REVISED RESPONSE TO REQUEST FOR ADDITIONAL INFORMATION

APR1400 Design Certification

Docket No. 52-046

RAI No.: 255-8285
SRP Section: 03.08.05 – Foundations
Application Section: 03.08.05
Date of RAI Issue: 10/19/2015

Figure1 Redistribution areas for maximum toe bearing pressure

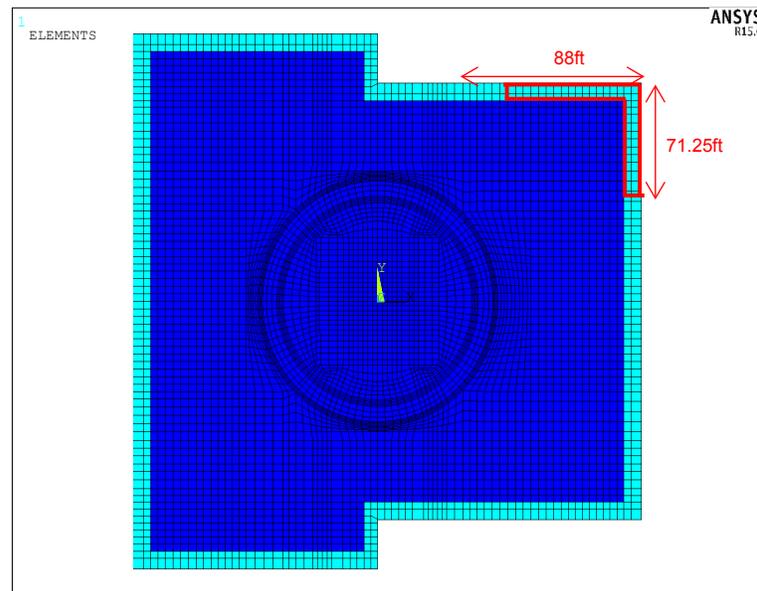
- b. Explain whether this was done only for stability check or for all aspects of design: developing member forces for design, stability evaluation (sliding and overturning), uplift evaluation analysis, basemat soil bearing pressure calculation, settlement analysis, and lateral soil pressure on foundation walls. Wherever, this approach was used should be justified

Due to a singularity, dynamic bearing pressures near the edge of the foundation tend to result in higher values than other areas of the foundation. However, as reported in the technical literature (see F.E. Richart and R.V. Whitman, "Footing Vibrations - Comparison of Test Results with Theory," University of Michigan, IP-755, November 1966), theoretical equations result in very high bearing pressures near the edges of the basemat due to a singularity. In accordance with the postulated pressure distribution for the combined static and dynamic loads, the bearing failure point moves away from the edge of the basemat. Therefore, it demonstrates a need for a more realistic treatment of the theoretically derived peak pressures near the edges. Maximum dynamic bearing pressures are calculated to consider the redistribution of peak bearing pressures over a more reasonable range of distances from the edge or corner of the basemat.

For a reasonable range of distances from the edge or corner of the basemat, distance inward from the edge of a basemat equal to the wall thickness plus 1/2 of the basemat thickness is used. Twenty-five percent of the length in significant stiffness wall connecting to the basemat is determined as length of redistribution along the edge of the basemat based on contact pressure contour.

Inward distance: wall thickness (4 feet) + 1/2 basemat thickness (10 feet) = 9 feet

Length of redistribution along the edge of basemat: Refer to Figure 1.
